Project: 10-20-25 QT #0847 GAINESVILLE, GA

Project: 10-20-25 QT #0847 GAINESVILLE, GA  
Function: Test, Adjust, & Balance

## Project Summary

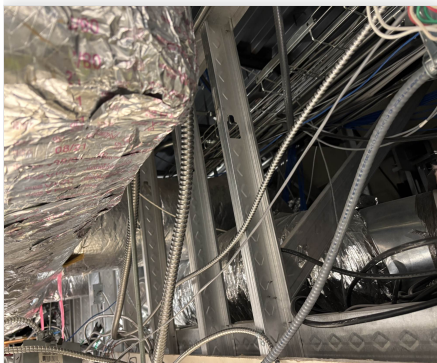
**Issue Name :** RTU-3: Kitchen Diffusers Incorrect Style  
**Description :** Kitchen diffusers 3-1, 3-2, 3-3, and 3-4 are substitutes until the correct Titus Diffusers can be installed.  
**Created By :** National TAB                      **Assigned To :** National TAB - Dan Hertenstein  
**Status :** Open  
**Priority :** High                                      **Asset Tag :**  
**Originated Date :** 10/23/2025 - Sagar Patel - National TAB

- **11/25/2025 National TAB - Sagar Patel**
  - Substitute diffusers are still in place of Titus diffusers.

- **11/04/2025 National TAB - Ben Searles**
  - DIFFUSERS REMAIN INCORRECT

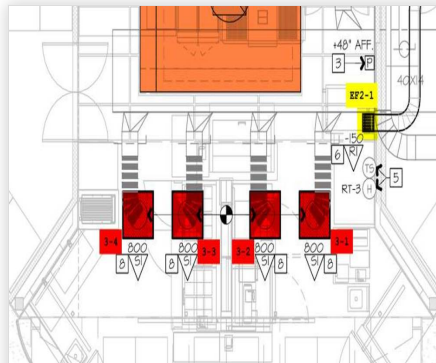
**Issue Name :** RTU-3: Kitchen Supply Diffuser Ductwork Incorrect  
**Description :** RTU-3 Diffusers 3-1 and 3-4 in the kitchen are not connected to the supply duct. They are still connected to the return duct. This will need to be corrected. RTU 3 is balanced to total design airflow.  
**Created By :** National TAB                      **Assigned To :** National TAB - Dan Hertenstein  
**Status :** Closed  
**Priority :** Urgent                                      **Asset Tag :**  
**Originated Date :** 10/23/2025 - Sagar Patel - National TAB
